A.K.M. KNIT WEAR LTD. (Extension)

24 March 2024

2. Observations

2.7 Material

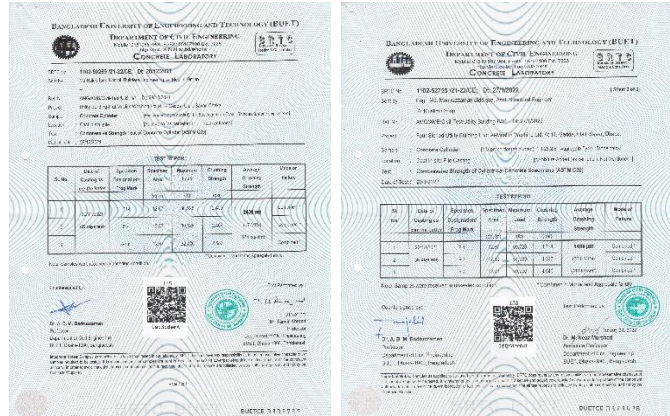
Observation-1: The design report required to be revised. (Utility Building II)

Description: In the design report, the compressive strength of concrete was considered 4000 psi. The factory has provided only 4 sets of concrete cylinder test reports from the pile, but no cylinder test report was found from the column, beam & slab. Which doesn't comply with the frequency of testing requirement of BNBC (section- 5.12.2).

SL No.	Observation	Action Plan	Timeline
01.	The design report required to be revised. (Utility Building II)	The building engineer is required to verify in-situ concrete strength by taking cores from lower-tier columns. Otherwise, consider minimum concrete strength.	within 6 weeks

02.	The design report required to be revised. (Utility Building II)	The building engineer is required to check & confirm the design strength in the design report and submit it to RSC.	within 6 weeks

Observation-4: Connection Gap. (External Steel Stair, Utility Building II)

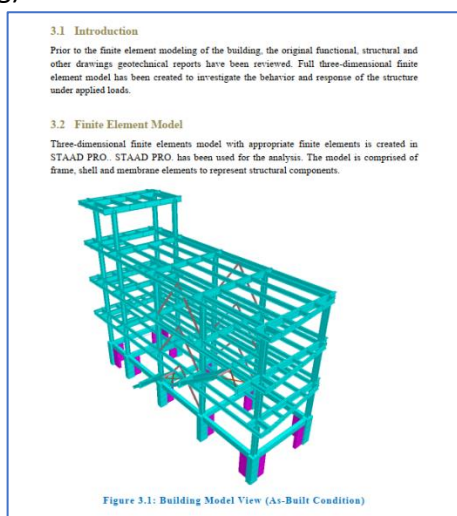
Description: Connection gaps were observed in the steel beam column joint. The building engineer is required to carry out suitable remedial works.

07.	Connection Gap. (External Steel Stair, Utility Building II)	The building engineer is required to carry out suitable remedial works.	within 6 weeks
08.	Mismatches in as-built drawings. (Childcare Building)	The building engineer is required to prepare as-built drawings reflecting the on-site condition.	within 6 weeks
